IN THE DRAWINGS

The Examiner stated that the sheets of drawings filed on April 8, 2002 have been received but not approved because Applicants have not submitted a proposed drawing correction in the form of a pen-and-ink sketch showing the changes in red.

Part of #24
LOCK1260-1
1 of 9

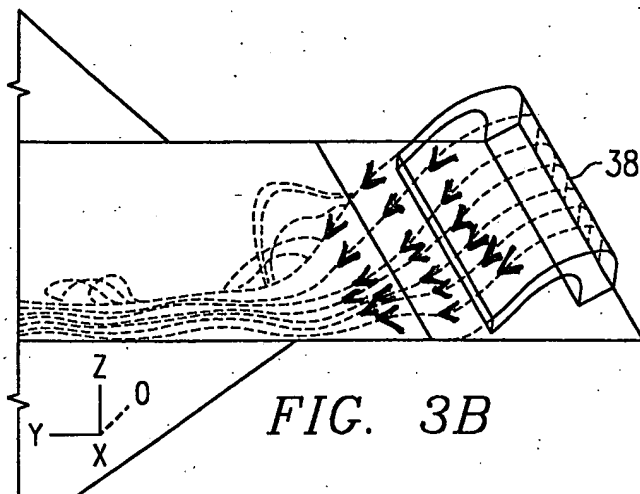
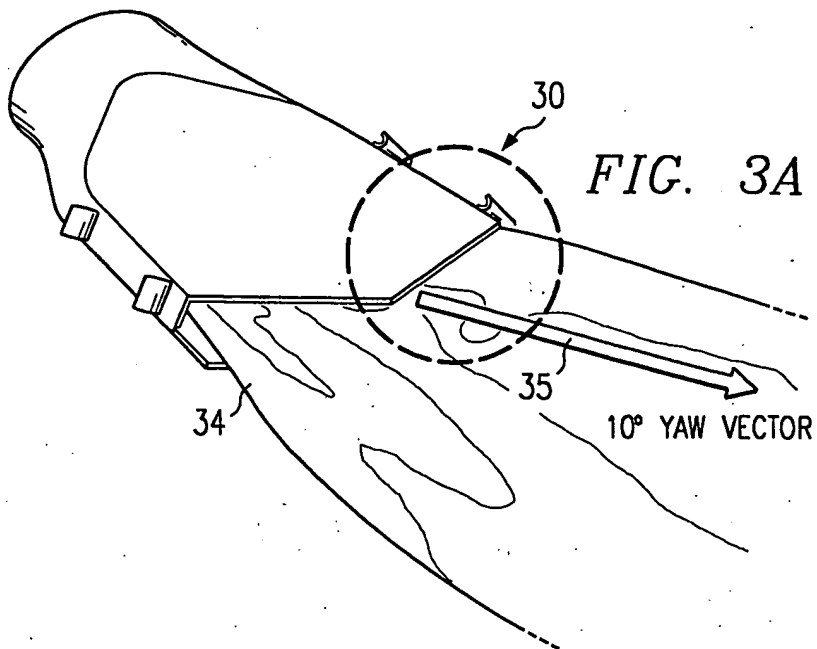
Applicants respectfully submit that flow arrows for the injected fluid have been added to Figures 2B, 3B, 3C, 3D, and 3E. Applicants respectfully submit that the pitch vector has been modified in Figure 5B to more clearly show that this vector has a vertical component directing the vector into the page.

FIG. 10

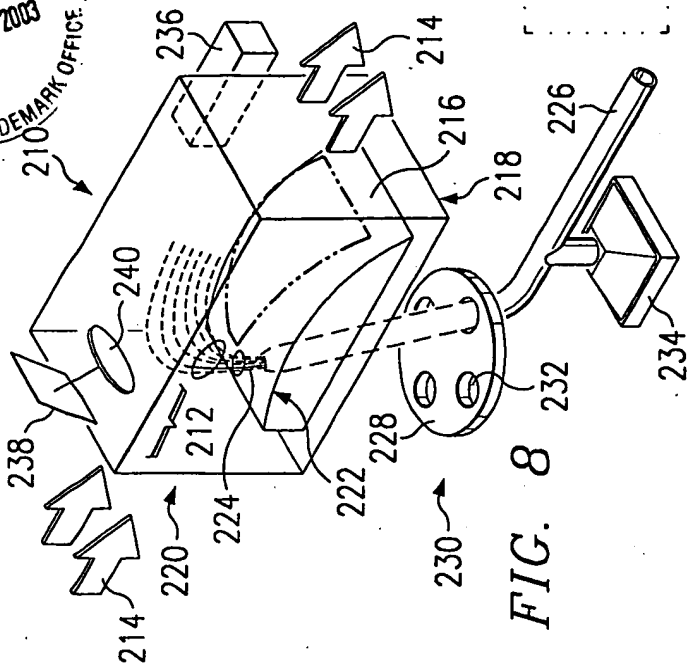
Applicants respectfully submit that the angle for 286 of 15° is relative to the longitudinal axis of the engine.
